Project Name: Chimmens Solar Farm

Report Name: Response to LLFA Holding Objection

This document provides a response to the holding objection received from Kent County Council as Lead Local Flood Authority to the proposed Chimmens Solar Farm (application no: 23/03181/FUL). The holding objection was received on the 16th January 2024 from Lucy Senior (Flood Risk Officer). The LLFA's comments are enclosed at the end of this document.

PROPOSED SWALE ADDITIONS
SHEET 1

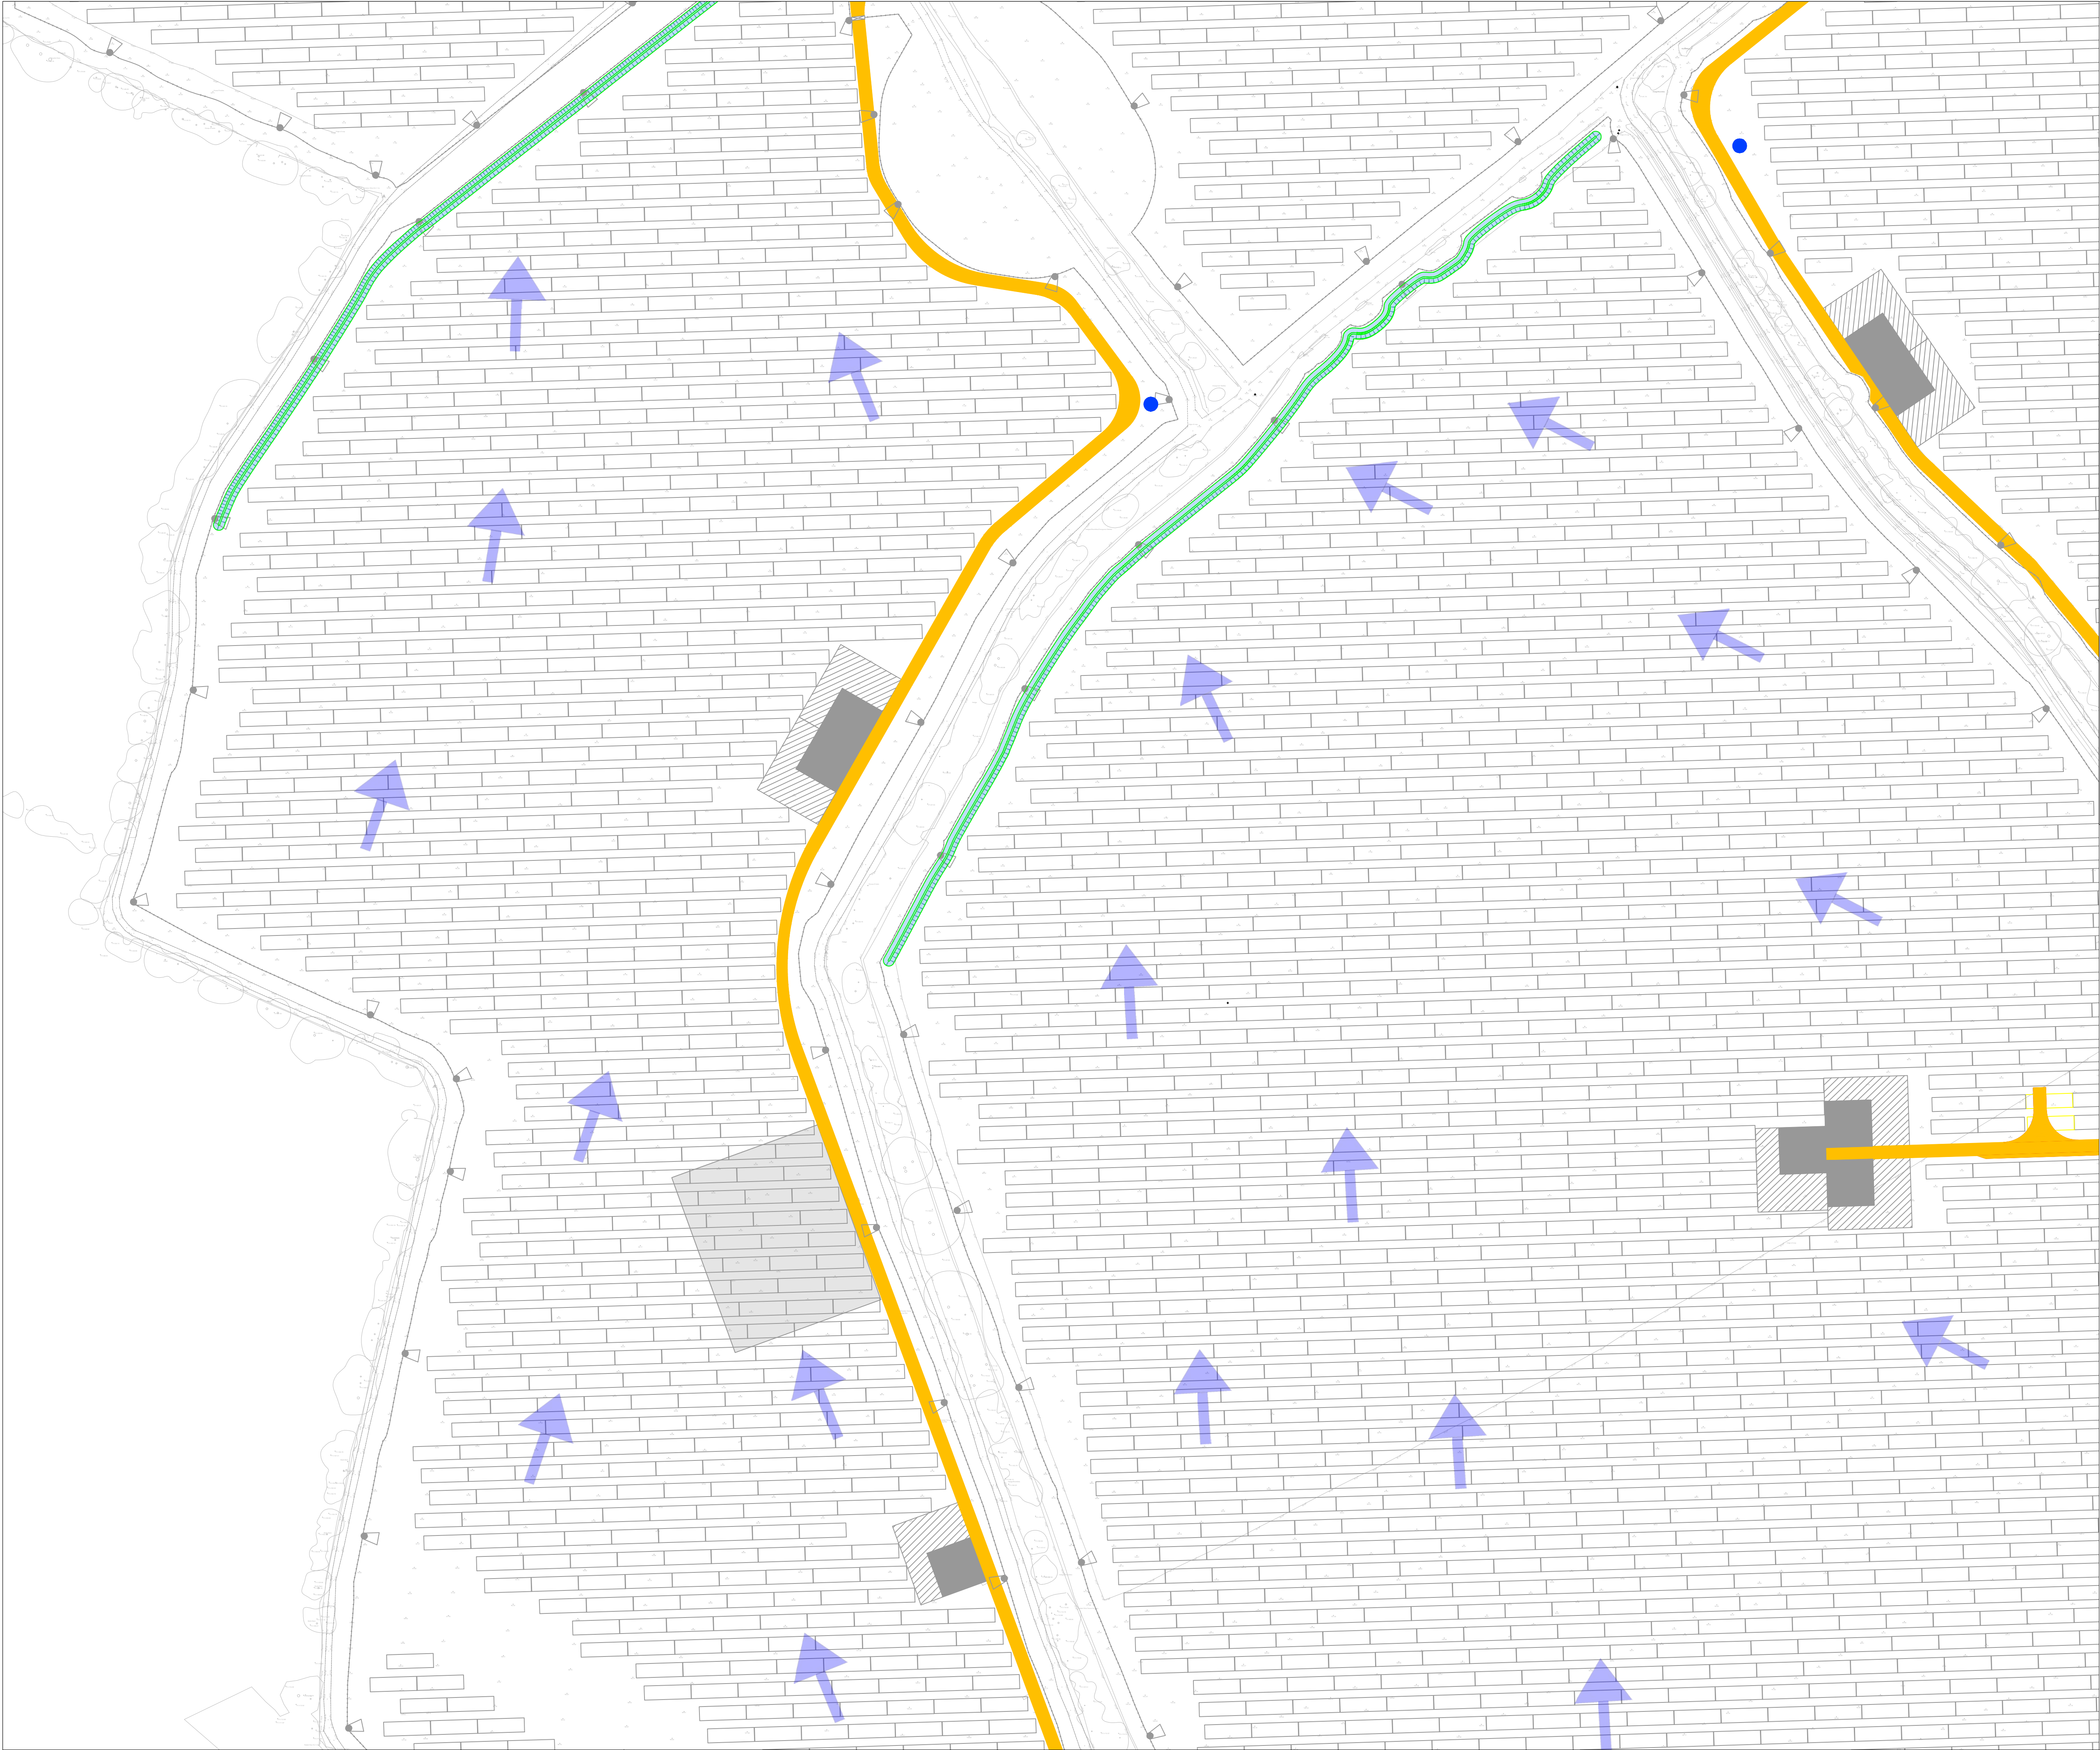
We expect that any rainfall upon the **solar arrays** will generally be shed between the rows of the panels onto the ground and whilst we have no objections to this in principle, given it is proposed to utilise various forms of meadow planting and to chisel plough the site in order to protect from soil mobilisation/erosion there are other concerns raised. Given the permeable nature of the soils and the gradients present there is a risk that a greater volume of overland flows could be experienced as a result of the concentrated volumes of water from the panels falling onto a smaller area of land than previously experienced. It is essential that volumes of runoff are not increased to safeguard neighbouring areas of land.

Whilst understanding that the chisel ploughing will help to hold back water on site; in order to minimise any potential risk of overland flows, we would seek that additional measures of runoff protection are examined further. Some of these measures may include:

- Incorporating bunds, filter drains or other measures to interrupt flows of water between rows of solar arrays to disperse water flows over the surface and promote infiltration into the soils.
- Incorporating wide grassed filter strips at the downstream side of blocks of solar arrays and maintaining the grass at a long length to interrupt water flows and promote infiltration.

- Incorporating gravel filled filter drains or swales at the downstream side of blocks of solar arrays to help infiltrate run-off (where ground conditions allow).
- Vegetated strips through a combination of wildflowers and or grass along with buffer strips around the perimeter of the fields buffer strips will be left uncut to capture any runoff leaving the site.

In response to these concerns, we would like to point the LLFA to the proposed access track details. A typical access track detail is enclosed at the end of this document. The track section shows that the design has accounted for a drainage swale to be located on the downslope side to the access tracks. Many of the proposed solar panel blocks include an access track and associated drainage swale wrapping around them. These swales will help capture overland flows on site to reduce the risk of impacting neighbouring land. In addition, the proposed site layout and topographic survey have been reviewed to identify any locations at the downslope side of a proposed block of solar panels where there is not currently an access track and associated swale proposed. Here, additional swales have been added to capture any overland flows from the development and promote infiltration of this surface water. A drawing which highlights where current access track drainage swales are proposed and where additional swales will now also be proposed is enclosed at the end of this document. Stone will be placed at the end of solar table rows to allow for maintenance vehicles to turn across swales during operation of the solar farm.

In addition to raising concerns about surface water flows at the downslope side of blocks or solar arrays, the LLFA have also highlighted the risk of concentrated surface water flows between rows of solar panels, suggesting additional measures should be incorporated to mitigate this risk. In response to these concerns, we would like to direct the LLFA to the proposed Landscape Masterplan enclosed at the end of this document. The Landscape Masterplan highlights that below proposed solar panels, a "grazing mixture" will be planted to comprise "species-rich grassland". Land below the panels will not be left as bare ground. Cook and McCuen's 2013 report on the "Hydrologic Response of Solar Farms" states that "with well-maintained grass underneath the panels, the solar panels themselves do not have much effect on total volumes of the runoff". It is therefore considered that the proposed landscaping on site will offer sufficient mitigation measures against the potential for concentrated flow paths between rows of solar
